Access Compliance Report

Public Rights-of-Way

(Curb Ramps)

Intersection ID: 29377	Main Street: BUCKVALLEY_DR	Cross Street: EULER_WY	Location: SW
ADA ID: 26F98D2C6872	Ramp Type: PerpDiag	Initial Pass/Fail: Fail	Overall Compliance: No
Severity Score: 46.25			
Codes/Mitigation Info/Possible Solution		Field Measurements/Component Compliance

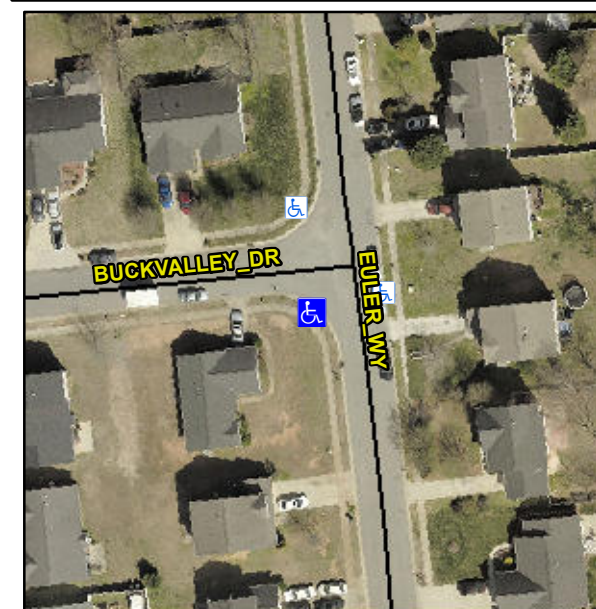
Not Found, R304.5.1, R304.2.2, R304.5.3

Compliance	Description	Data	Compliance	Description	Data
N/A	Ramp Length (in)	96.0	No	Ramp Slope (%)	10.1
No	Ramp Width (in)	46.5	No	Ramp XSlope (%)	7.1
N/A	Flare Type LT	N/A	N/A	Flare Type RT	N/A
N/A	Flare Slope LT (%)	N/A	N/A	Flare Slope RT (%)	N/A
N/A	Flare Traversable LT?	N/A	N/A	Flare Traversable RT?	N/A
N/A	Landing Length (in)	N/A	N/A	DWS Provided?	N/A
N/A	Landing Width (in)	N/A	N/A	DWS Contrast?	N/A
N/A	Landing Slope (%)	N/A	N/A	DWS Length (in)	N/A
N/A	Landing X Slope (%)	N/A	N/A	DWS Full Width?	N/A
N/A	Landing Curb? (Y/N)	N/A	N/A	DWS Offset (in)	N/A
N/A	Shared Landing?	N/A			
N/A	Gutter Ponding?	N/A	N/A	Gutter Slope (%)	N/A
N/A	Gutter Lip Ht (in)	N/A	N/A	Gutter X Slope (%)	N/A
N/A	Painted X Walk1?	No	N/A	Painted X Walk2?	No
	X Walk 1 Direction	To E		X Walk 2 Direction	To N
N/A	X Walk 1 Width (in)	N/A	N/A	X Walk 2 Width (in)	N/A
	X Walk 1 Slope (%)	3.2		X Walk 2 Slope (%)	3.3
	X Walk 1 X Slope (%)	3.8		X Walk 2 X Slope (%)	4.5

Remove & Replace Curb Ramp With Two New Directional Ramps or Equivalent.
